Date:	11 <sup>th</sup> October 2004	<b>Jabiru Aircraft Pty Ltd</b> Document No: JSB003-1	Filename: Page:	JSB003-1 1 of 2
Jabiru J400 Door Bolts

**SERVICE BULLETIN: JSB 003-1**

**Subject: Jabiru J400/J200 Door Bolts**

**Figure 1. Hinge Bolt Detail**

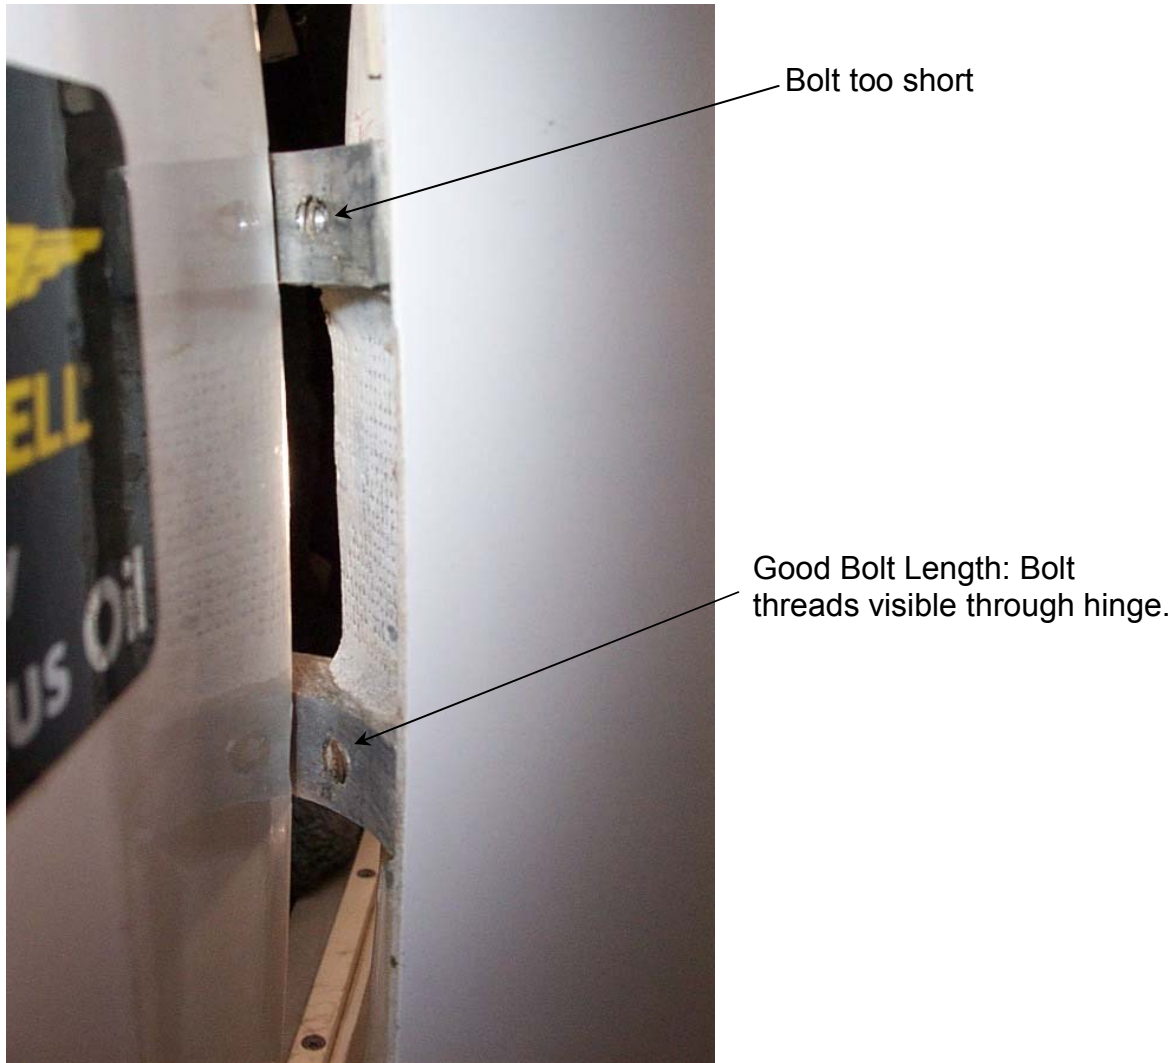
Some Builders of Jabiru J200/J400 series aircraft (All Jabiru Fuselages with 3 doors) have found that the bolts attaching the doors to the hinges are too short to positively engage the threads tapped in the aluminium hinges.

During the aircraft's next inspection, the hinges should be visually inspected. Refer to Figure 1 below.

If one or more of the attachment bolts are short, as shown in the top bolt above, they are to be replaced with a longer item. The attachment bolts are 1/4" UNC Socket Head Cap screws.
